Planning & Zoning Board Meeting

ZONING MEMORANDUM

Meritage Homes- Elevation/ Architectural Plans Hillside Groves (The Reserve PUD) Applicant: Meritage Homes

4R70 (Formerly Primose) - 2,596 s.f.

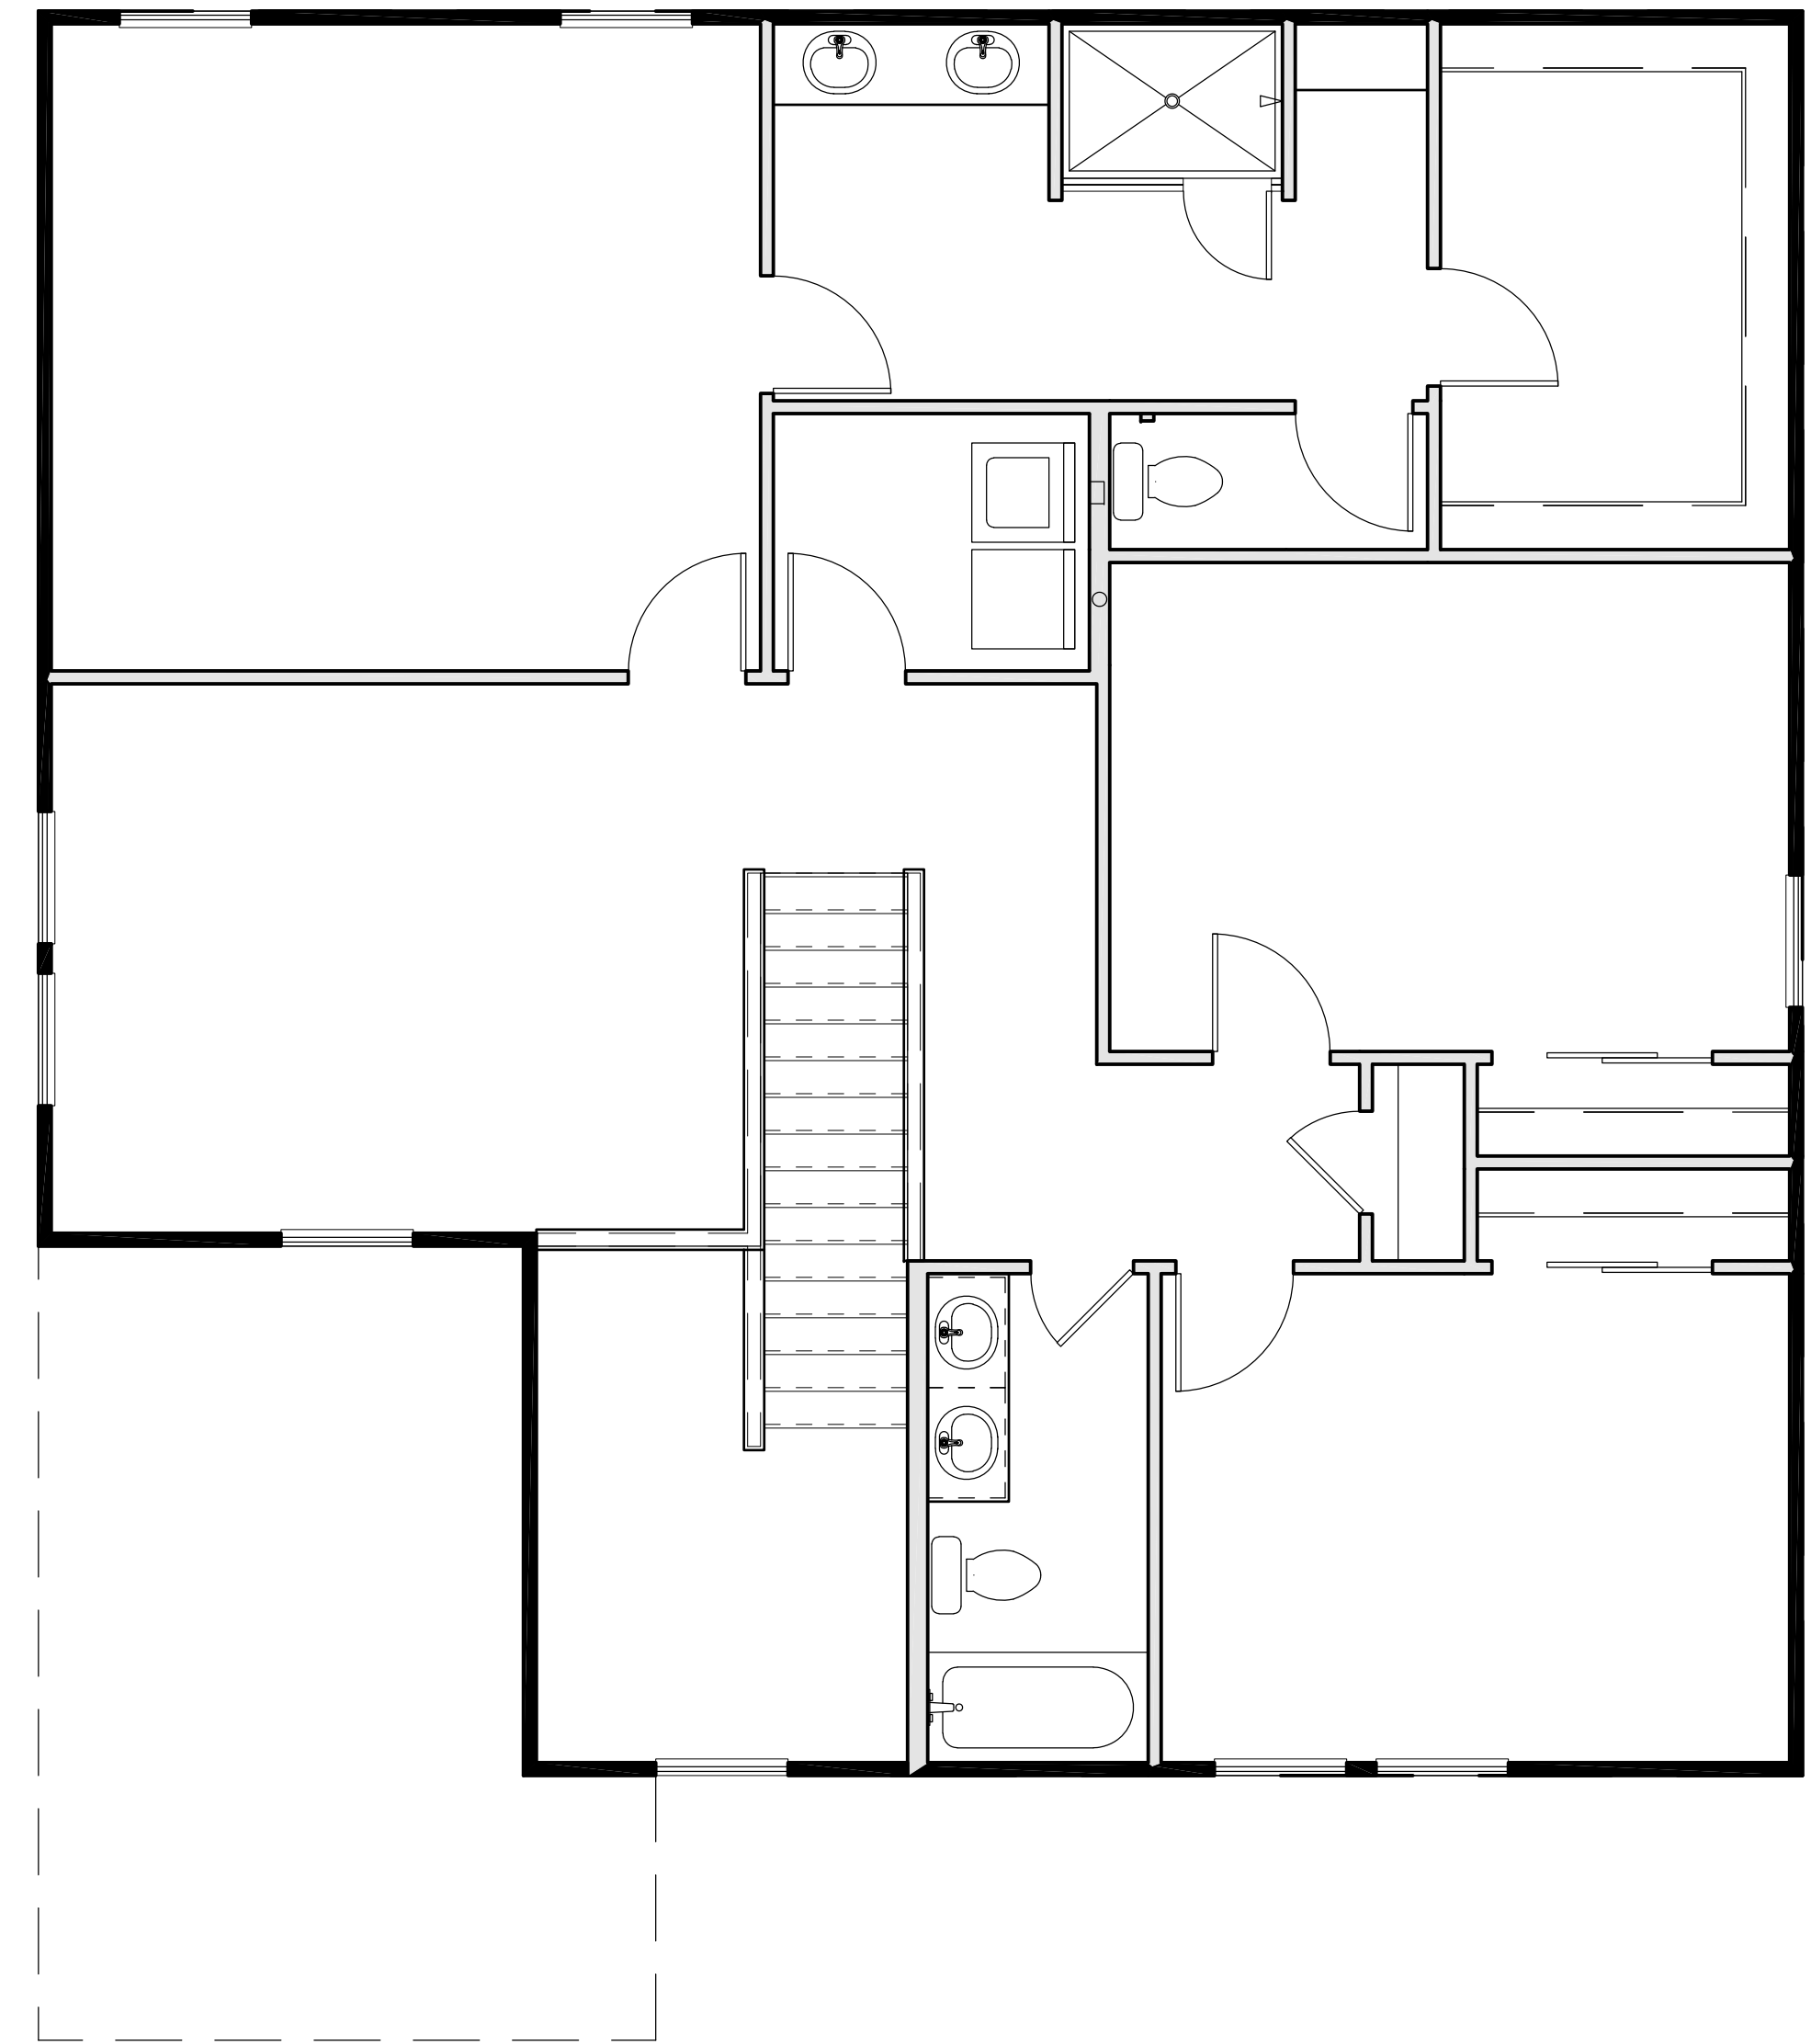
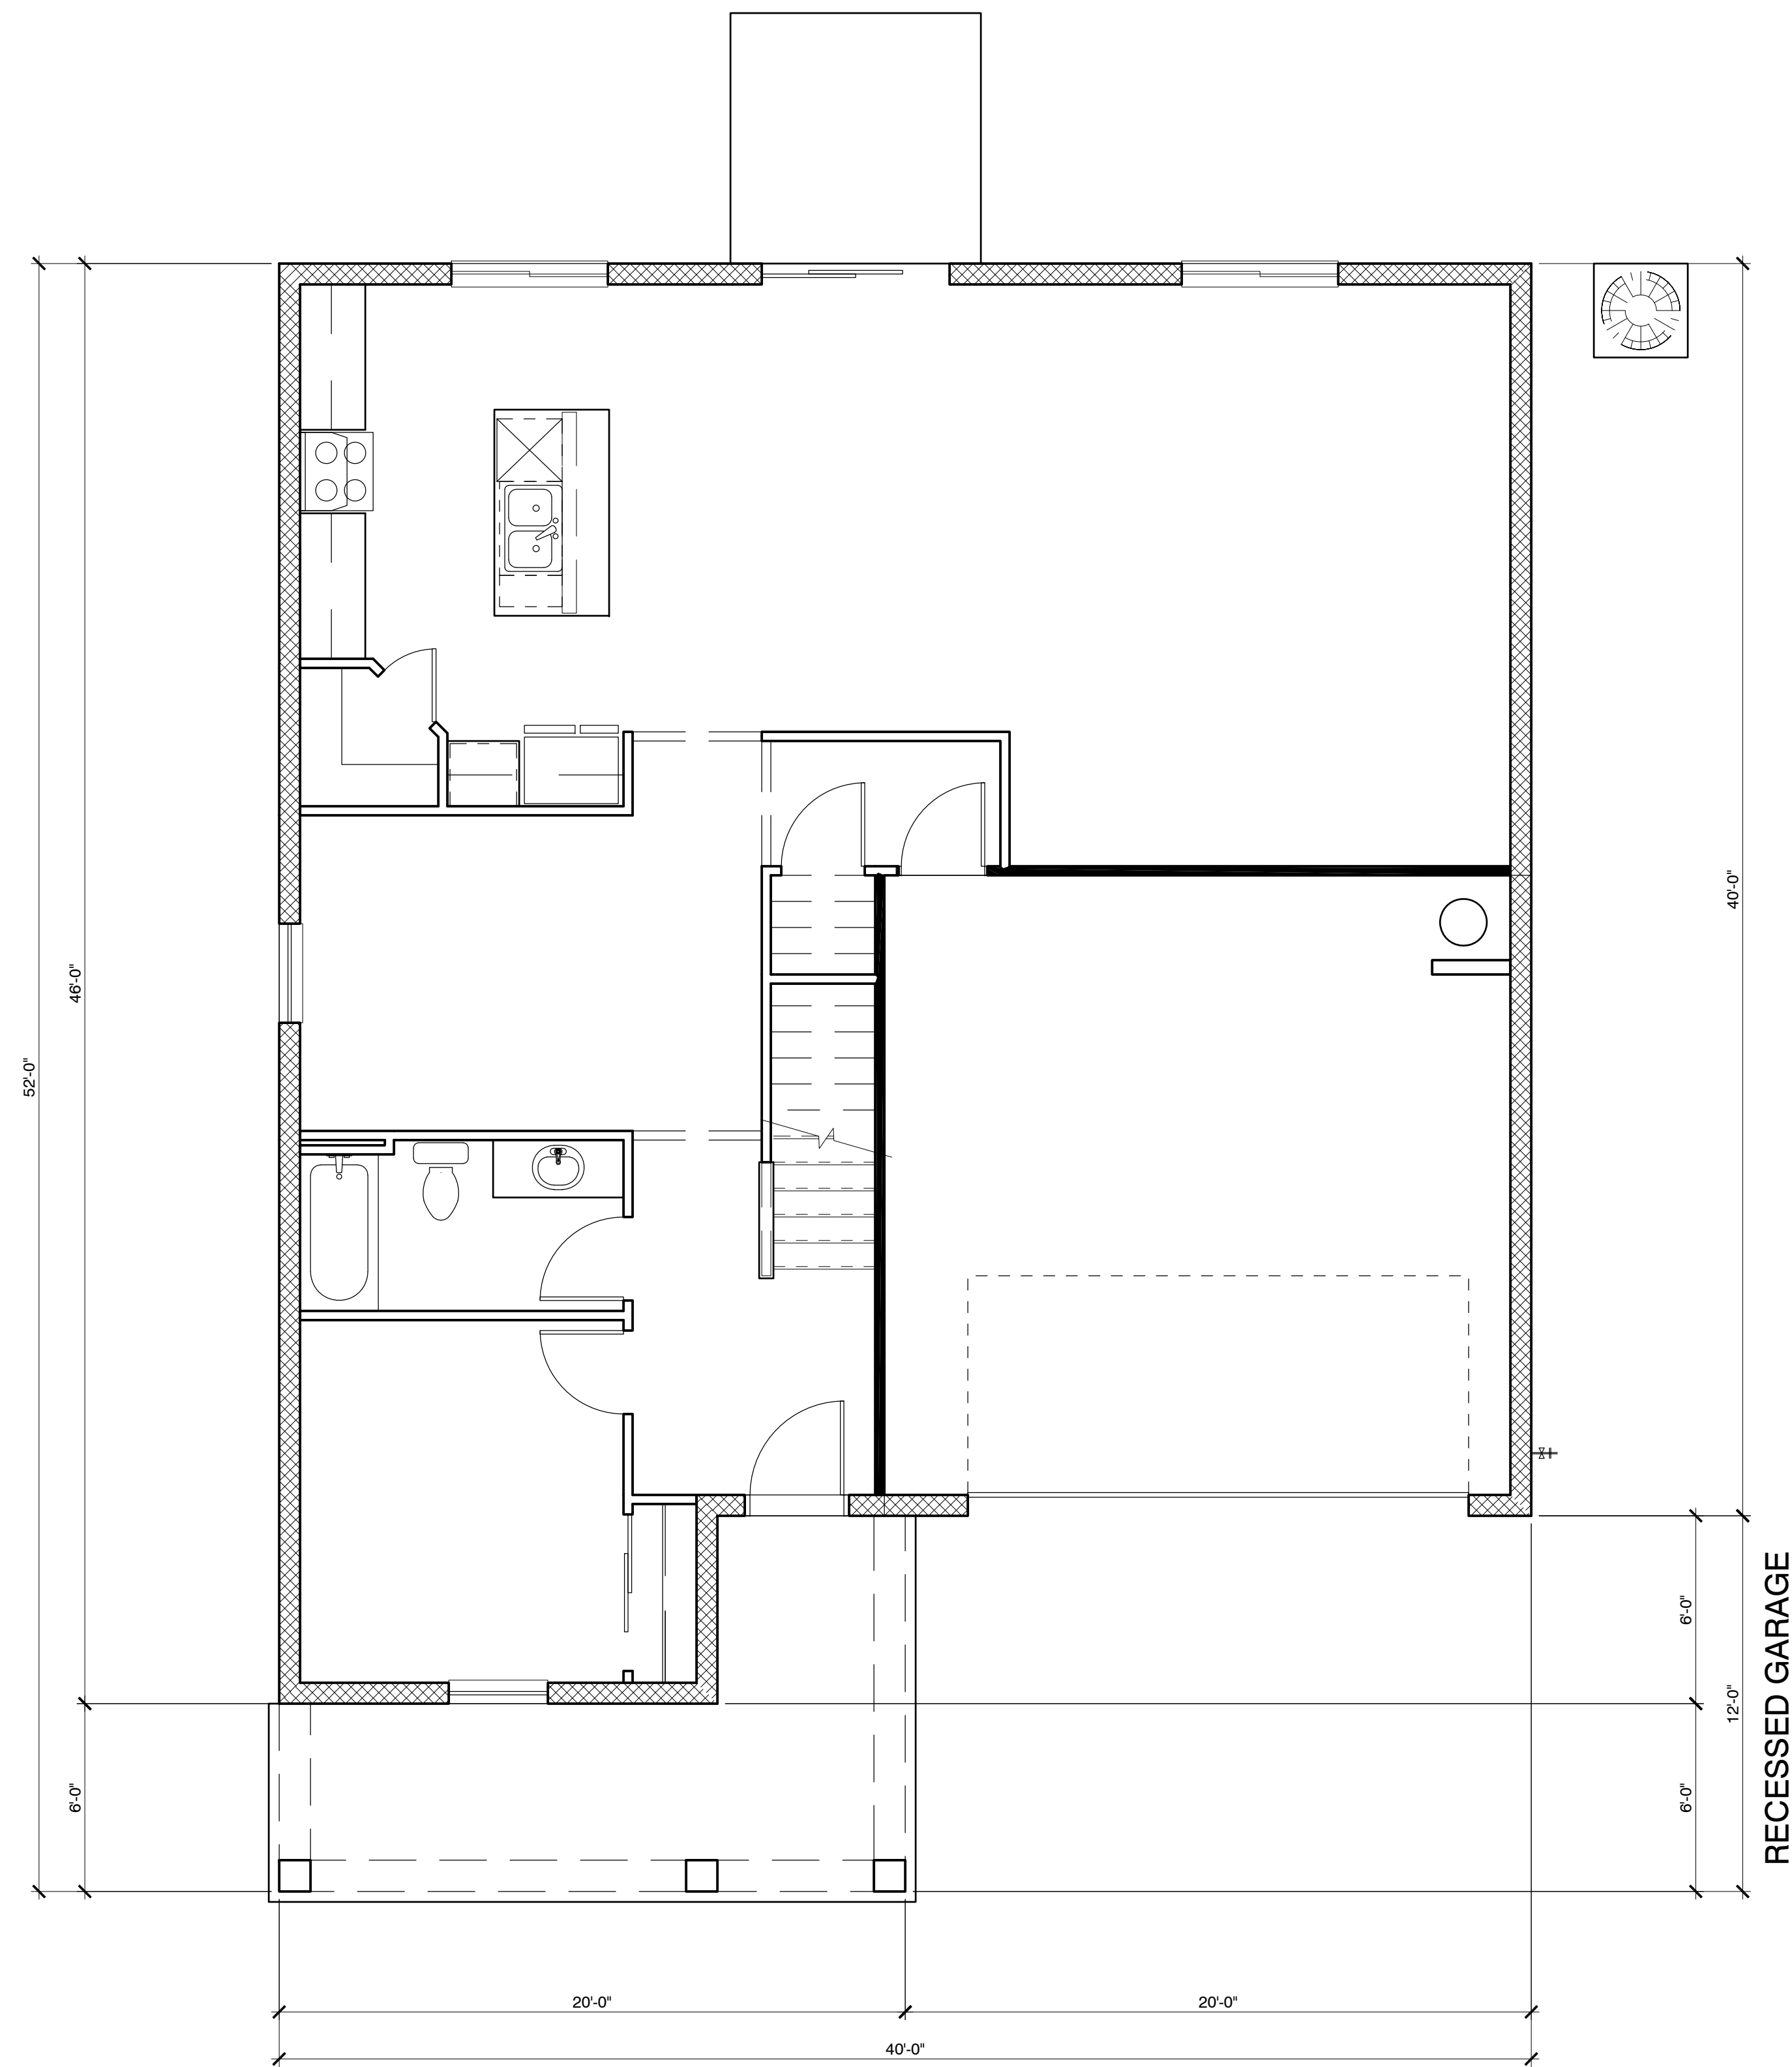
The proposed models appear to provide porches and recessed garages consistent with LDC Sec. 4.06.02 (A) (2) and (3). Additional detail on the porches would be helpful though to determine if they are at or above grade or have articulation designating them as usable front porches. As an example, none of the porches show railings as part of the design.

The proposed elevations show what appears to be stonework and varying materials on the models, however no product types, colors or materials are identified on the plans. The elevation plans need to be revised to demonstrate and specify materials to ensure that they are consistent with the following LDC Sections which state:

The proposed elevations do not identify the roof materials to be used nor detail on eave design. The plans need to be revised to demonstrate and specify roof materials and eaves detail to ensure that they are consistent with the following LDC Sections:

The application provides some of these details but not all that are required for each of the facades. Consistent with LDC Sec. 4.06.03, the plans need to be revised to show and label the front, side, and rear facade elevations for each model and identify the specific architectural details on each façade, demonstrating how they are consistent with the type and quantity required in LDC Sec. 4.06.03 (C).

Recommendation: The model elevations should be revised consistent with the requirements identified in the review comments below and be brought back to the Planning and Zoning Board for consideration.
